MY01 MONITORING REPORT

Hip Bone Creek Restoration Site
Chatham County
Cape Fear River Basin - 03040101

DMS Project #100059

Date: February 2, 2022
To: Jeremiah Dow, DMS Project Manager
From: Tim Morris, Project Manager
KCI Associates of North Carolina, PA
Subject: MY-01 Monitoring Report Comments
Hip Bone Creek DMS#100059, Contract 007528
Cape Fear River Basin CU 03040101
Chatham County, North Carolina

**CURRENT CONDITIONS PLANVIEW PAGE
HIP BONE CREEK RESTORATION SITE
CHATHAM COUNTY, NC**

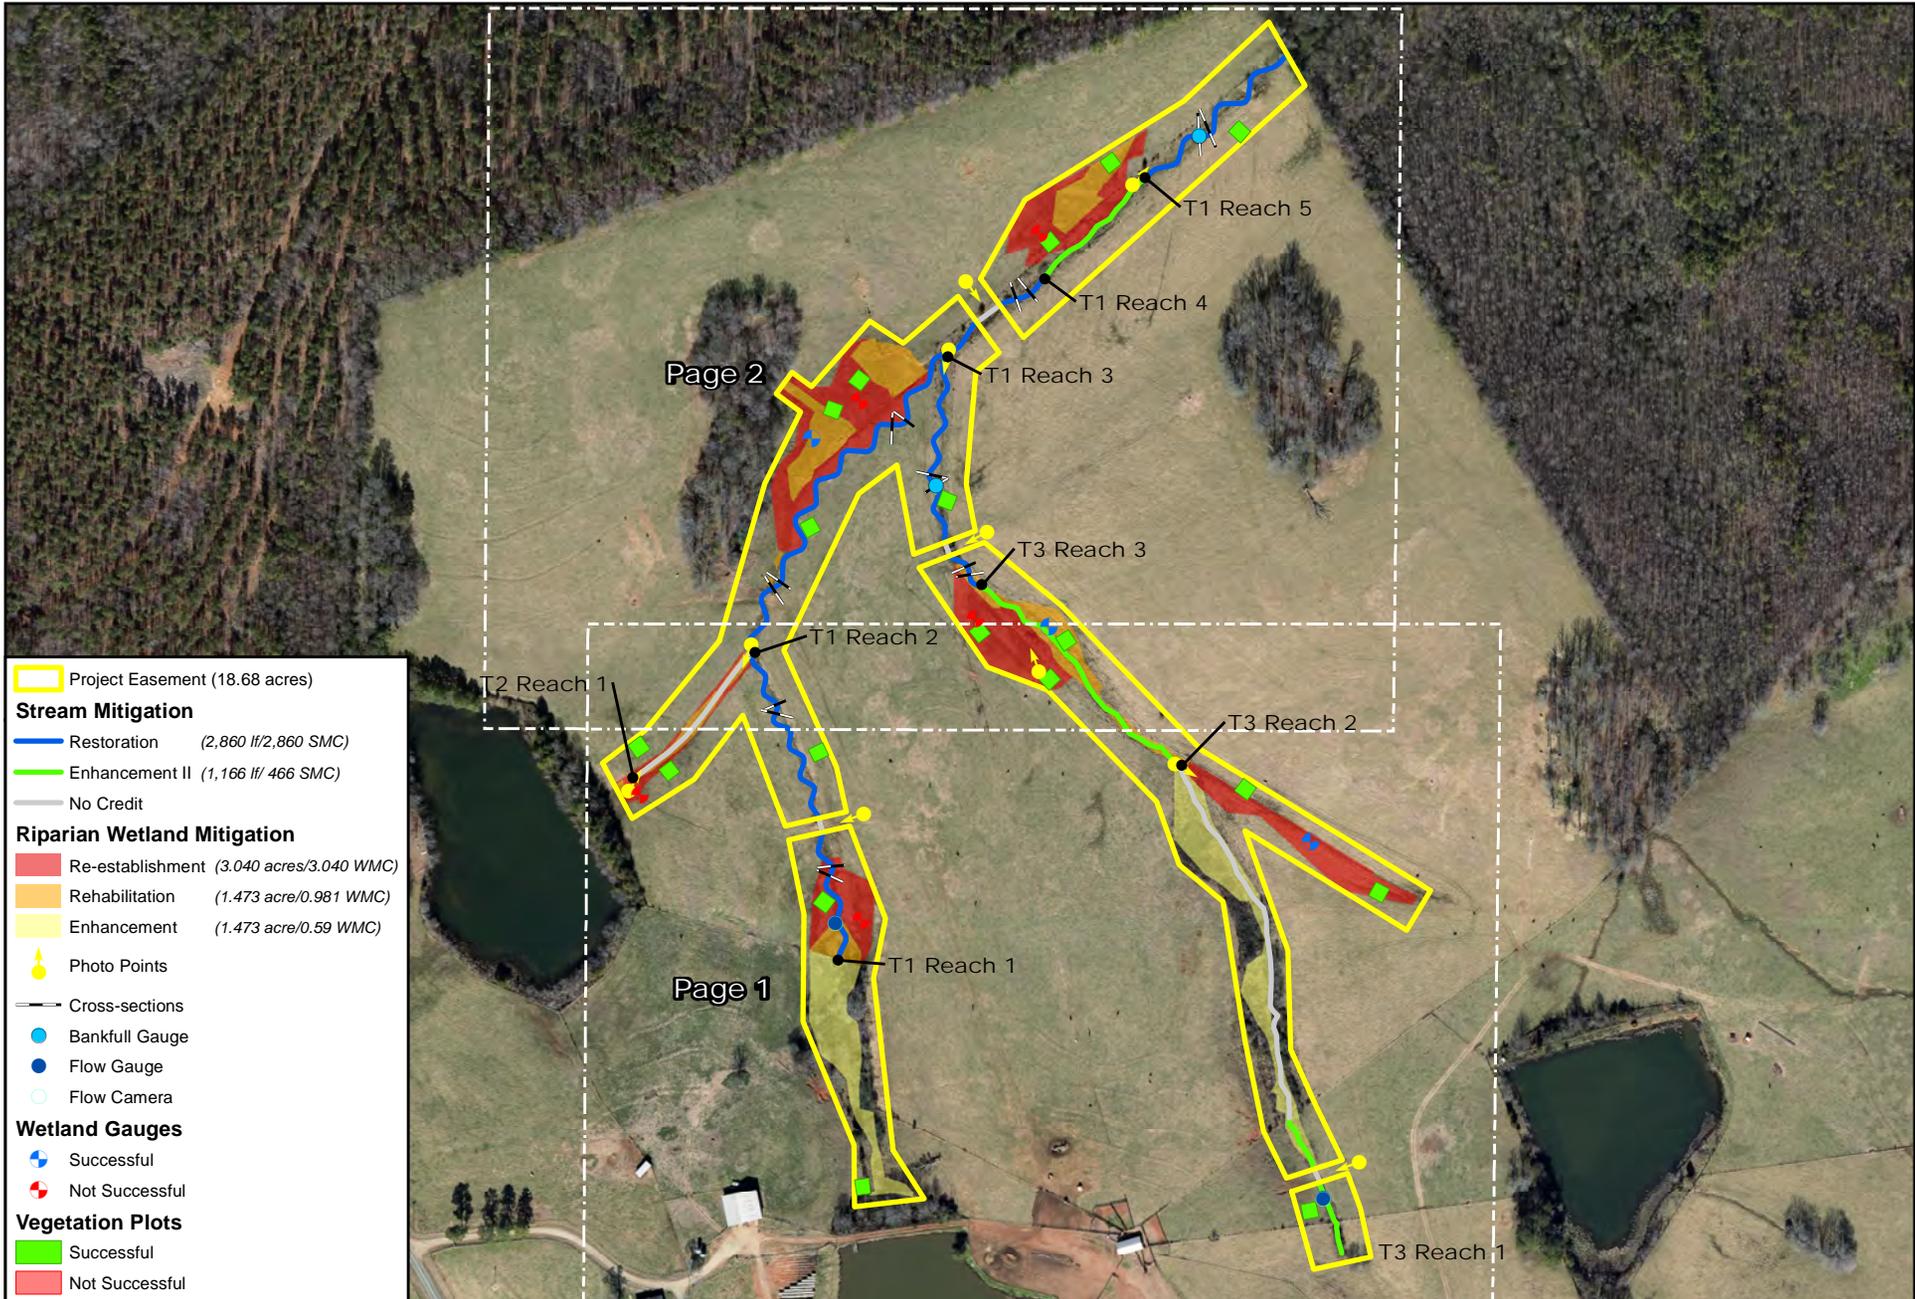
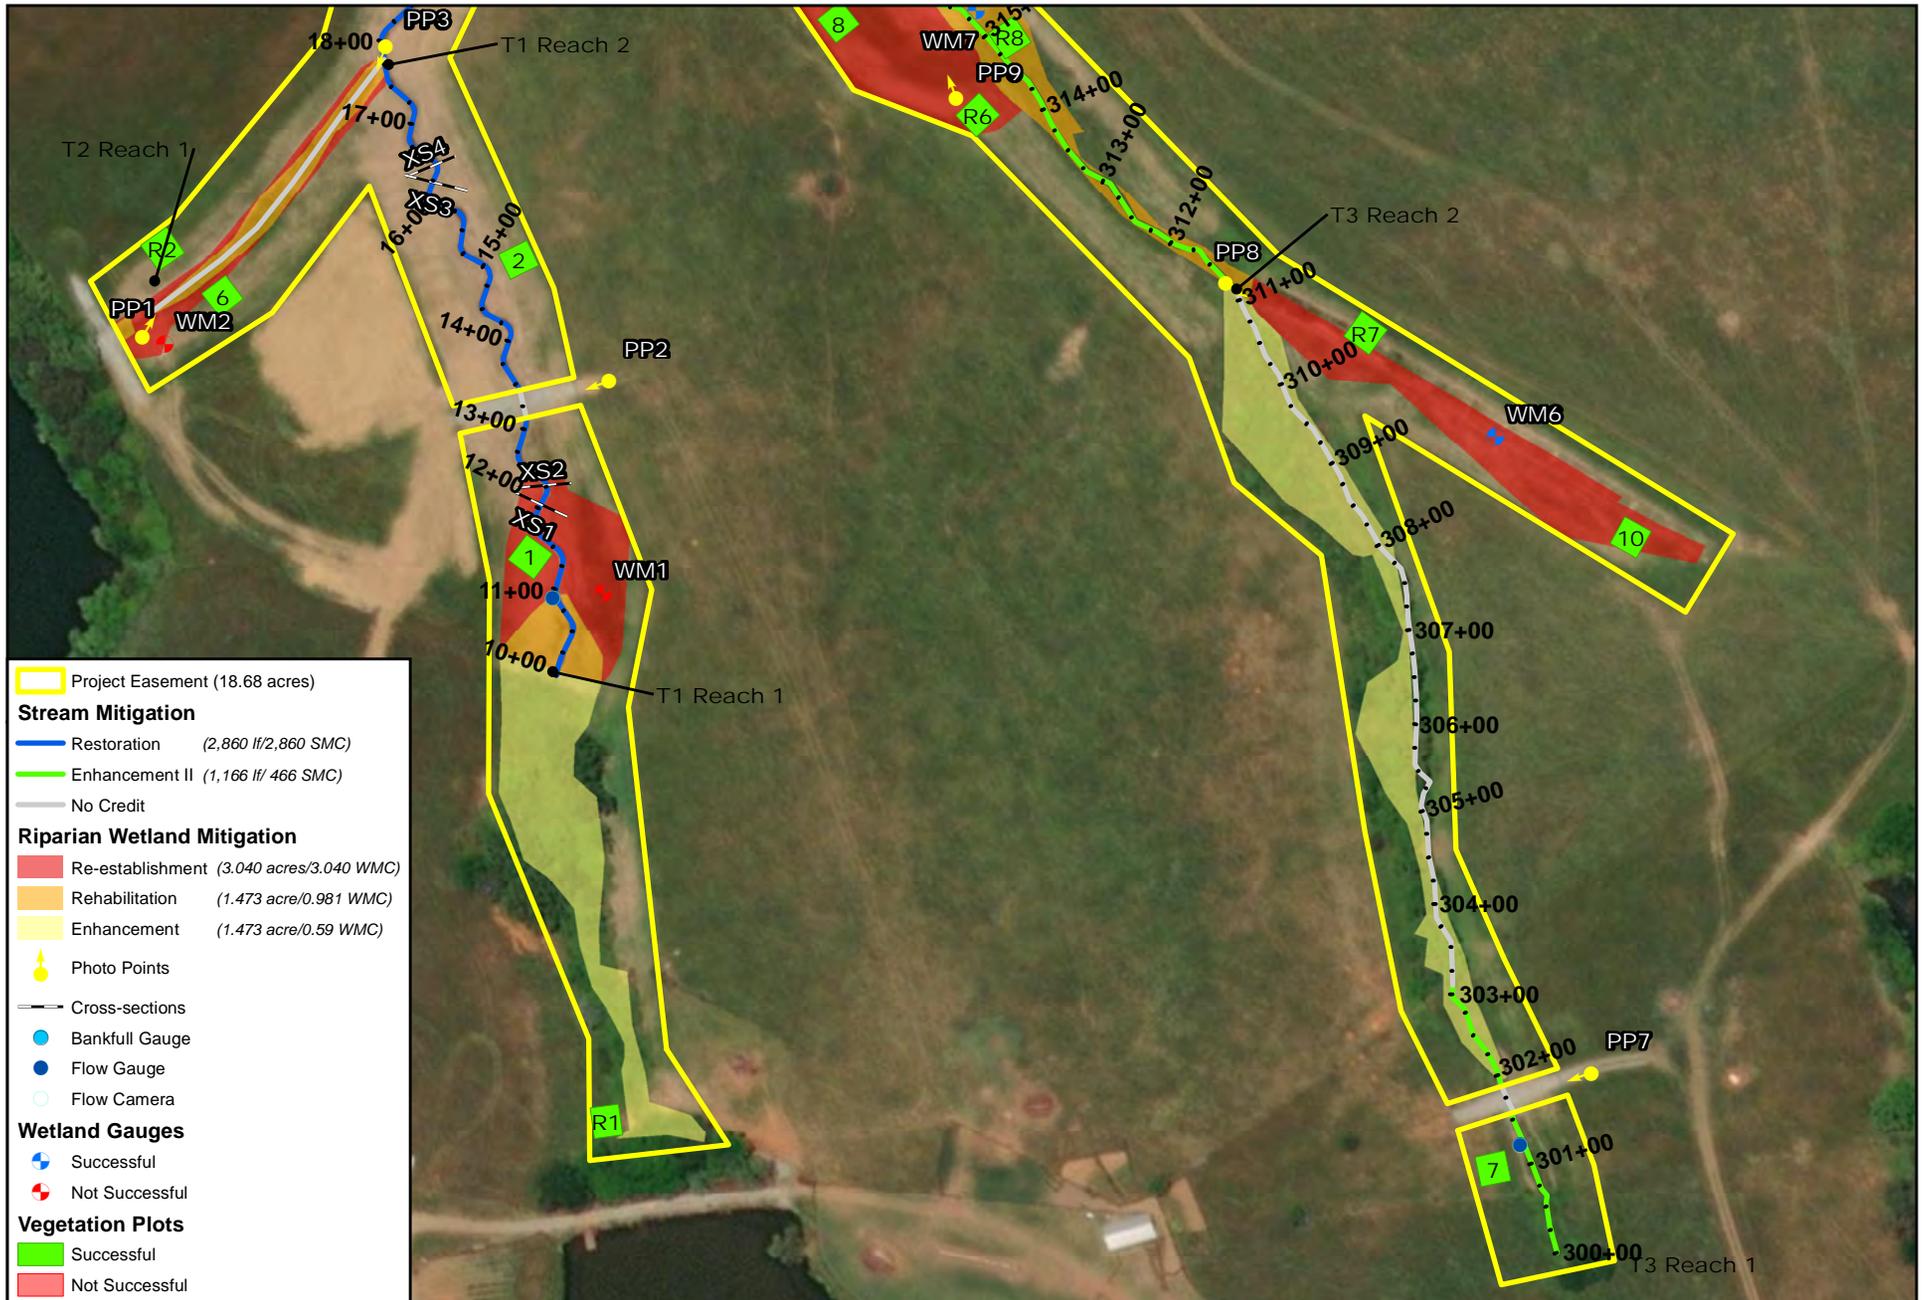
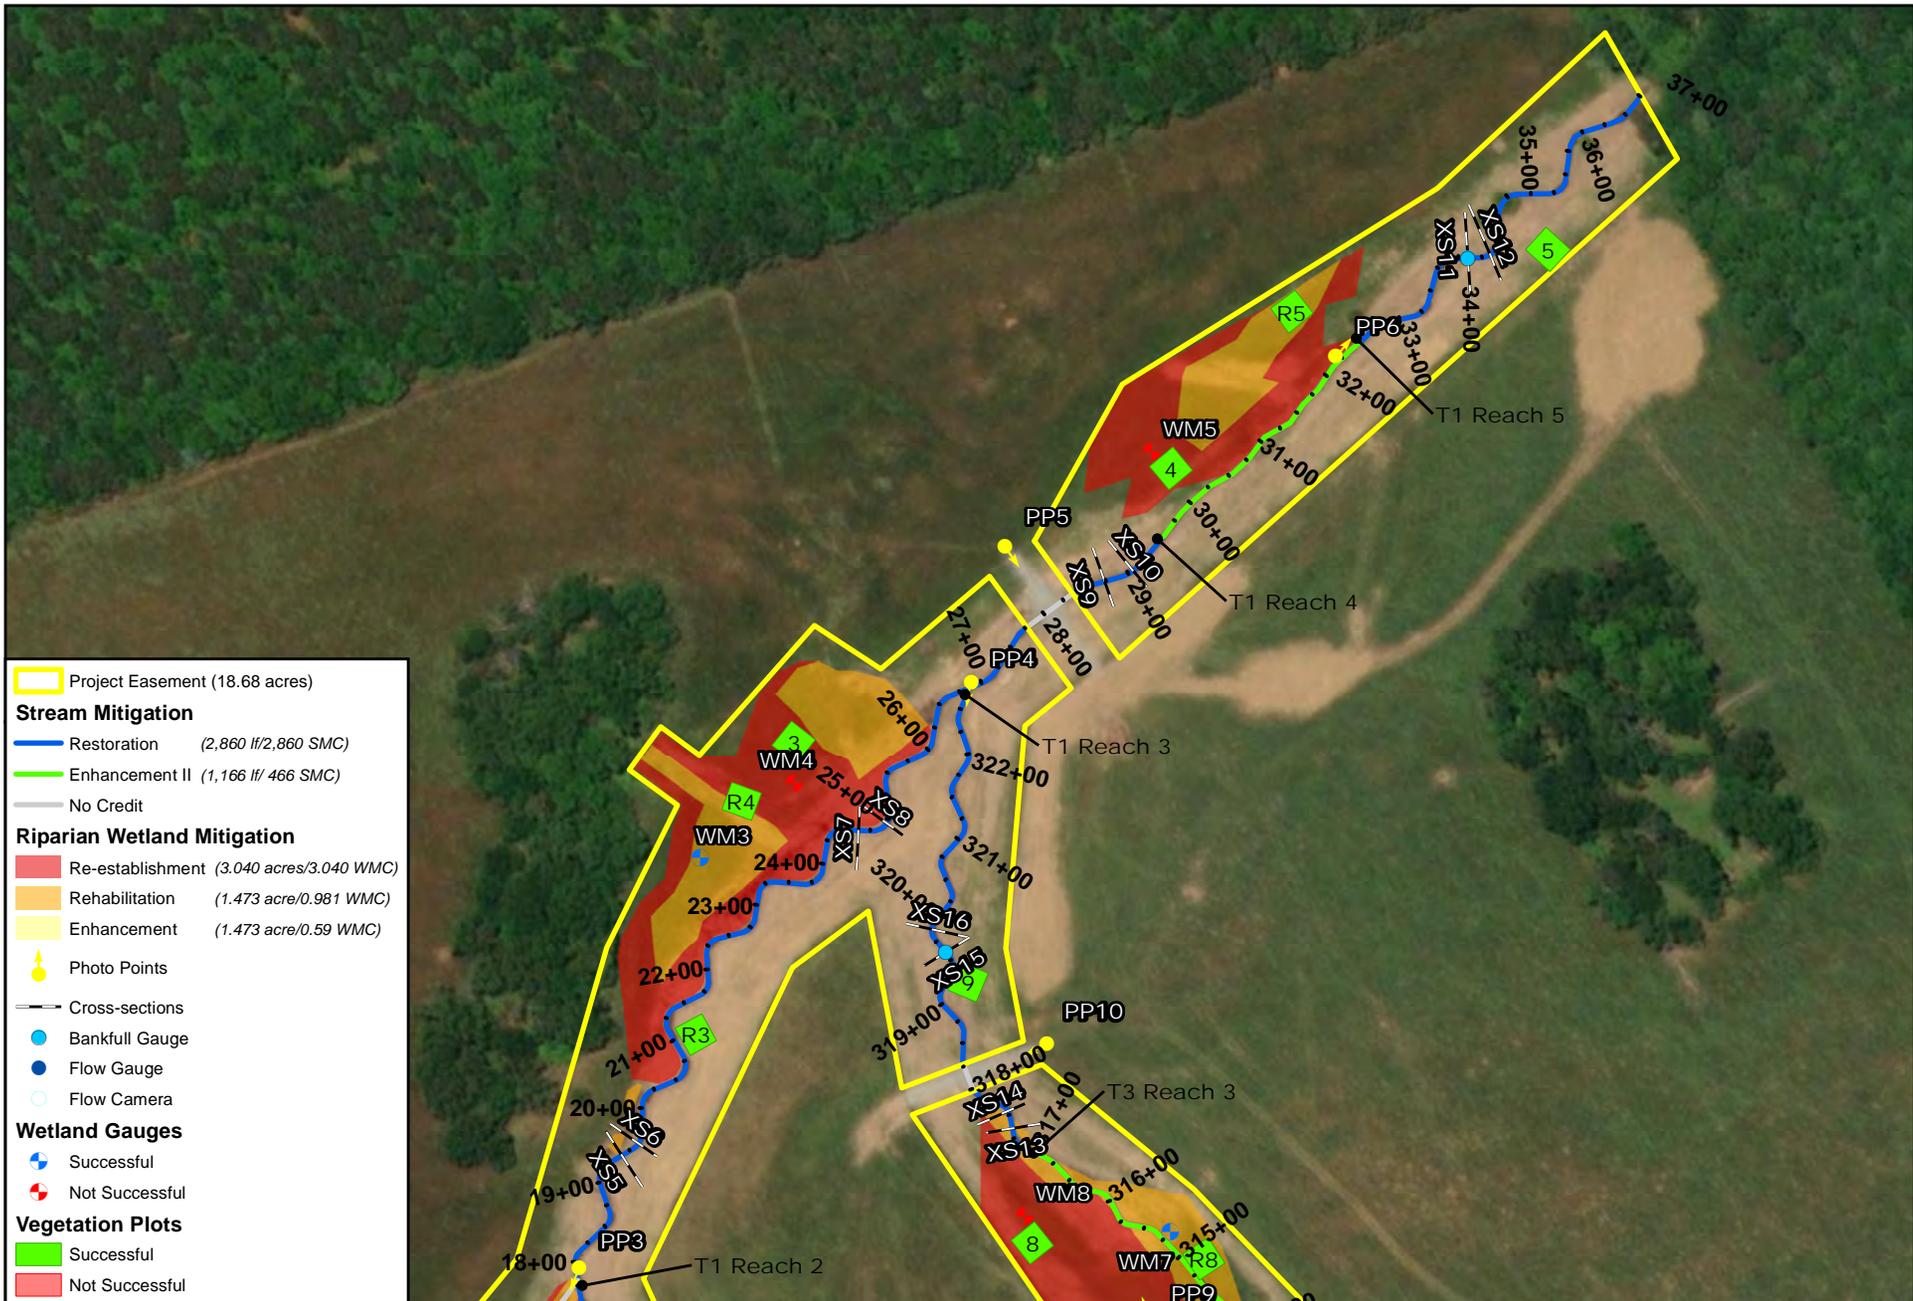
1. CCPV maps' satellite imagery did not render.
KCI Response: This issue has been corrected.
2. Please verify that no invasive vegetation was treated or identified.
KCI Response: Invasive species were treated during construction but have not been treated since construction was completed. Scattered clumps of Chinese privet are present in the wetland enhancement areas but below the mapping threshold. These will be treated again in future monitoring years.
